Subject: AP1000 Response to Request for Additional Information (SRP 3)

RAI-SRP3.7.1-SEB1-10 R2

Response to Request for Additional Information on SRP Section 3

RAI Response Number: RAI-SRP3.7.1-SEB1-10

## Response to Request For Additional Information (RAI)

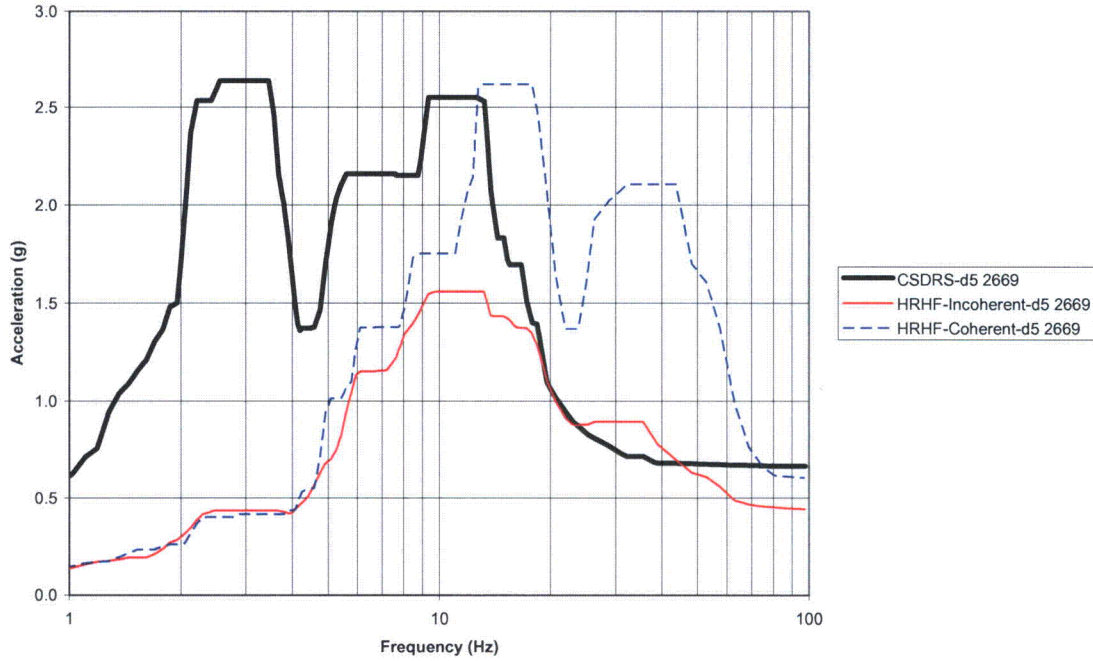
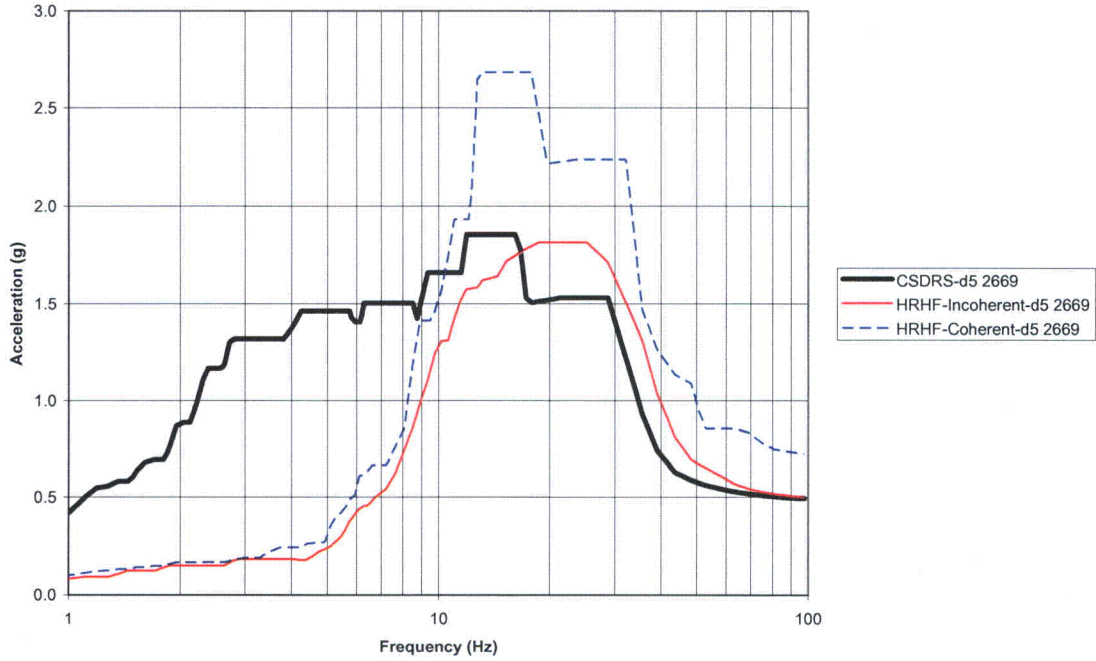
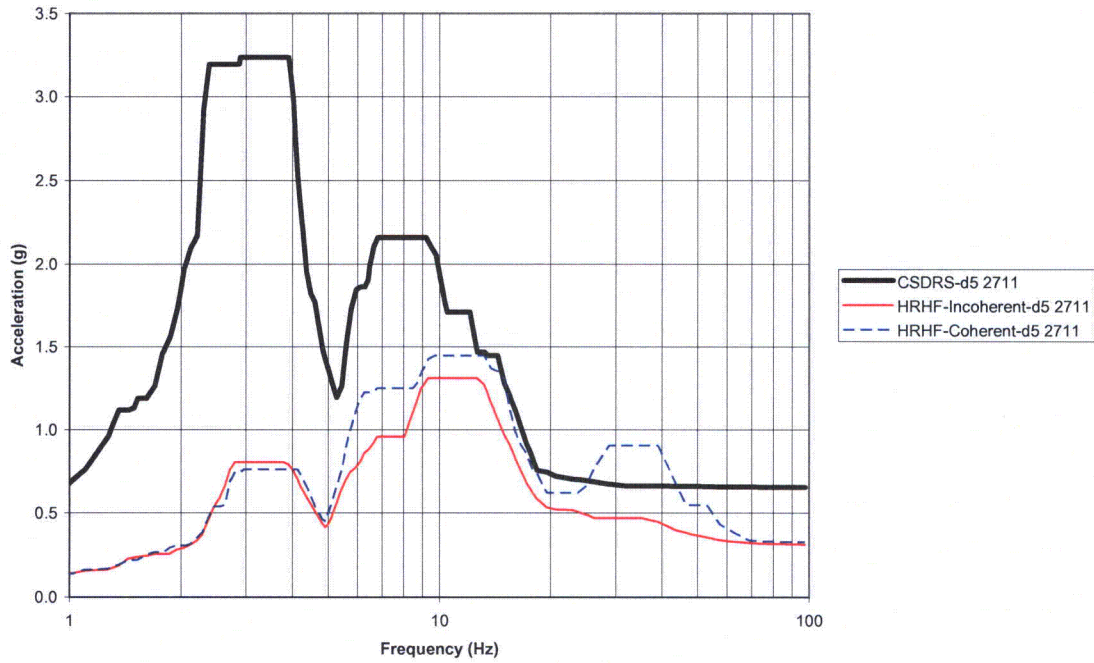
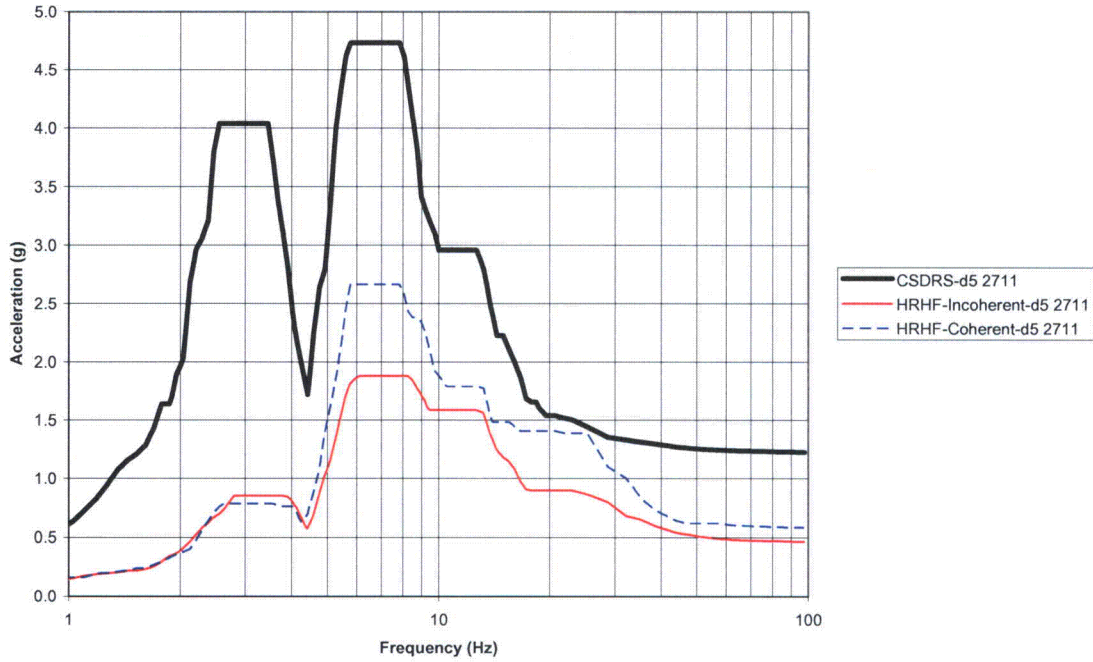
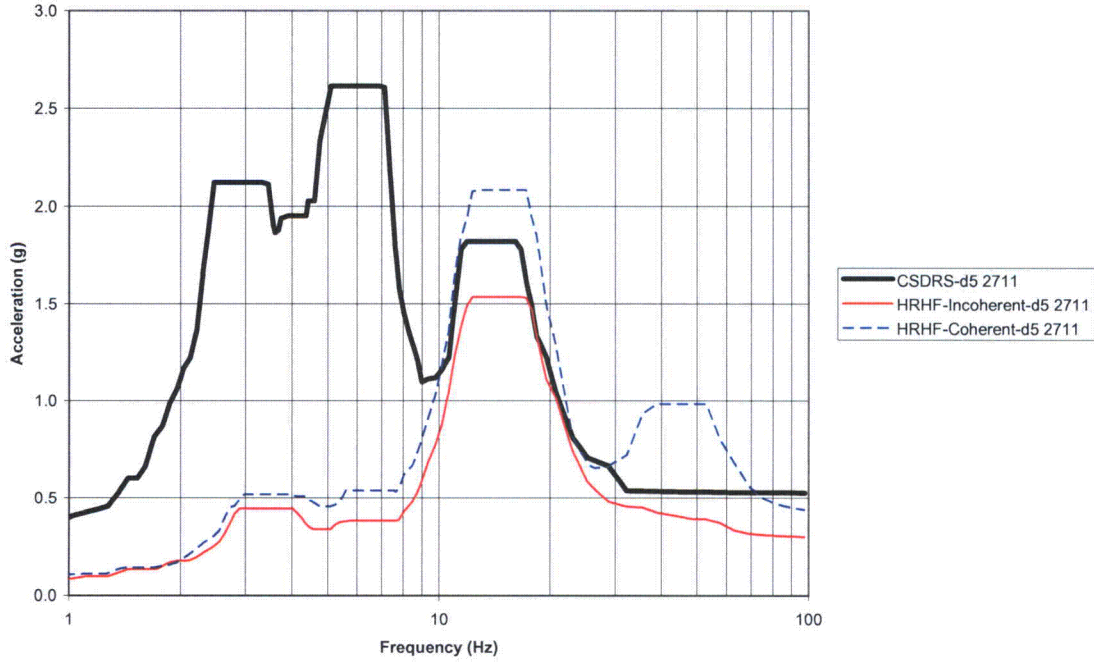
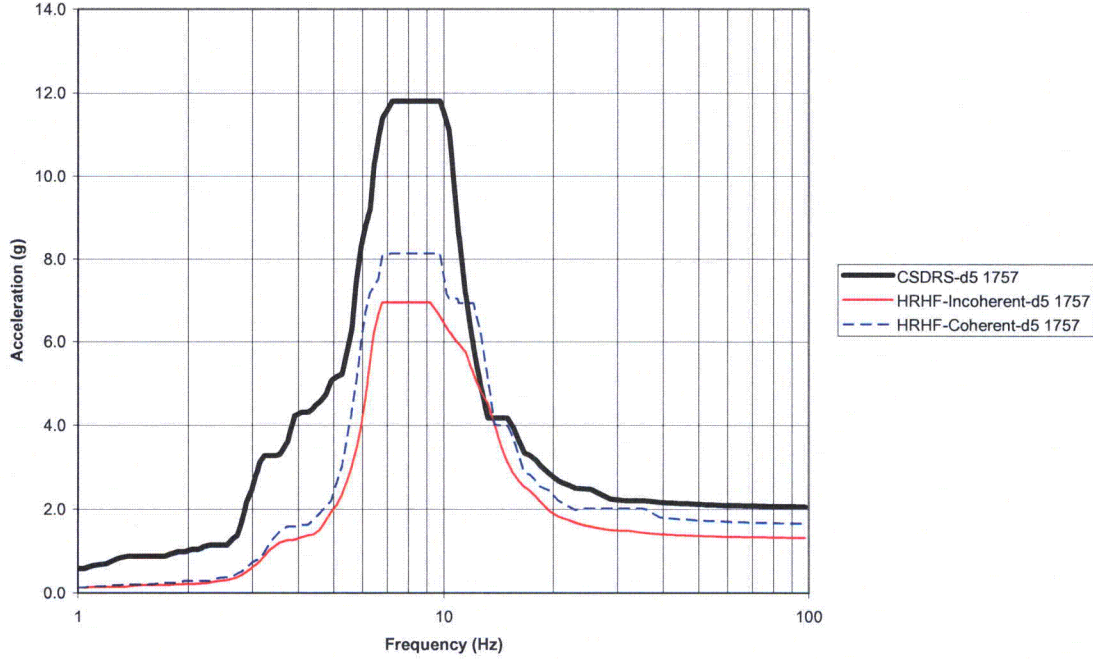
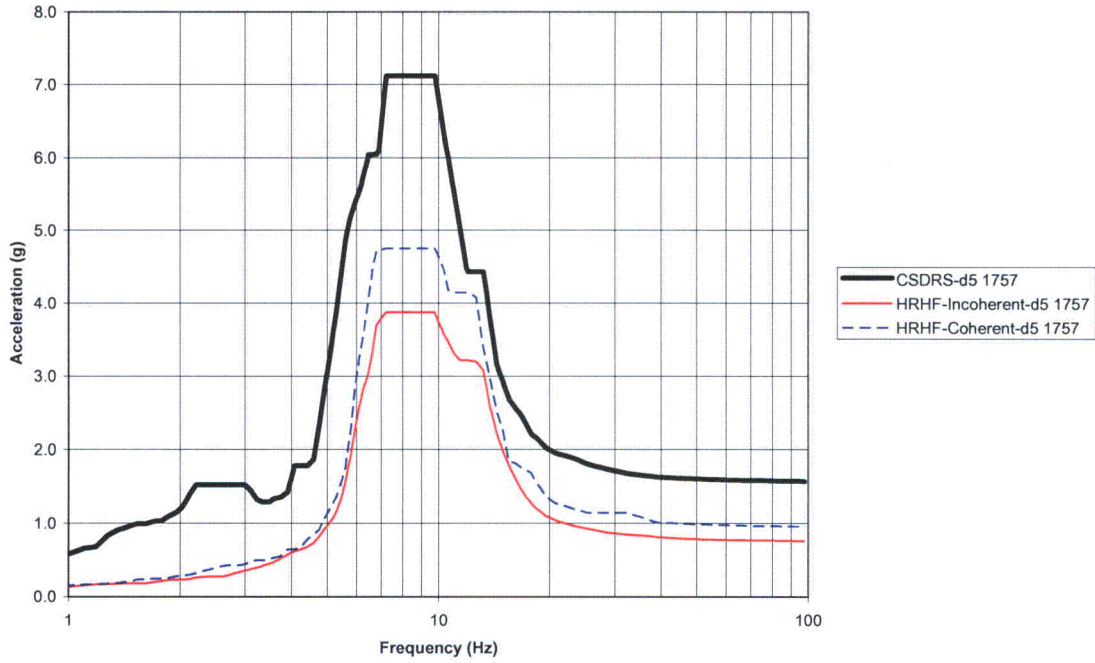
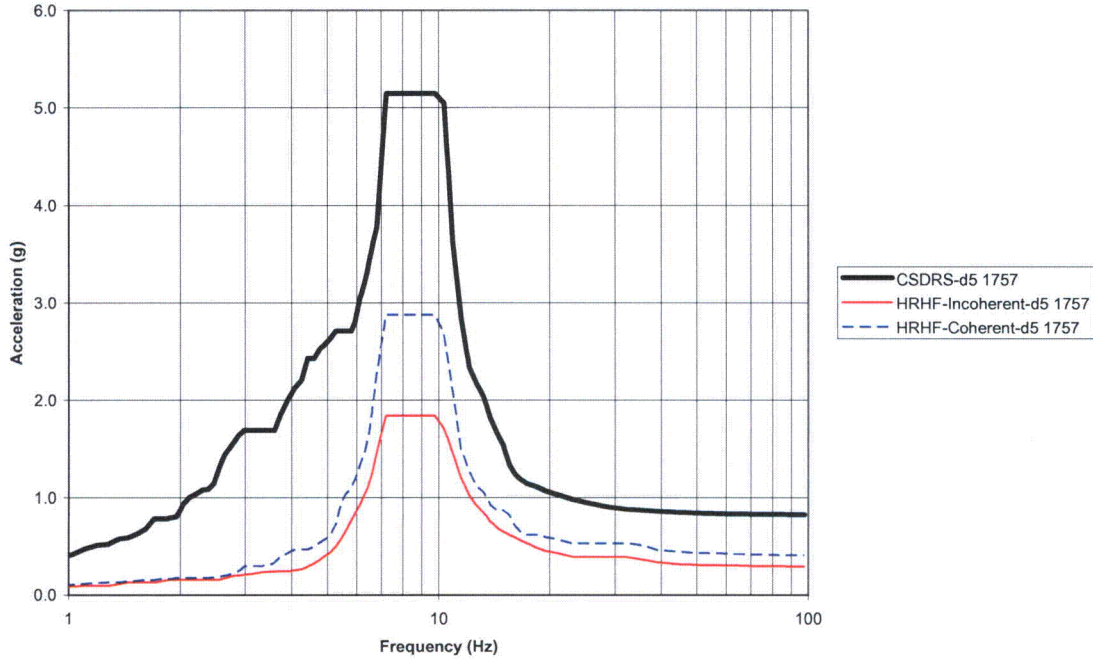
The staff requests that Westinghouse augment Figures 5.2-1 through 5.2-6 in TR-115, by adding the HRHF broadened spectra from the NI20 fixed base analysis, without any reduction for incoherency or other considerations. This will provide the staff with results needed to conduct an evaluation of the effect of incoherency.

In Figures RAI-SRP3.7.1-SEB1-10-1 to RAI-SRP3.7.1-SEB1-10-21 some of the reductions ratios (defined as Incoherent response / coherent response) are shown to be less than 0.5 in some cases. Analyses have been performed using the EPRI model to provide the staff with additional results needed to conduct an evaluation of the effect of incoherency. The results show that the size and shape of the basemat has a significant effect on the reductions obtained from incoherence.

In response to the question raised by the NRC during May 19-23, 2008, Westinghouse has provided the response spectra for the HRHF broadened NI20 model with coherent and incoherent considerations in Figure RAI-SRP3.7.1-SEB1-10-1 to RAI-SRP3.7.1-SEB1-10-21 (5% damping).

**Technical Report (TR) Revision:** The Figure RAI-SRP3.7.1-SEB1-10-1 to RAI-SRP3.7.1-SEB1-10-21 will replace Figure 5.2-1 through 5.2-6 in TR-115. See also RAI-SRP3.7.1-SEB1-11 for changes to Section 5.2.
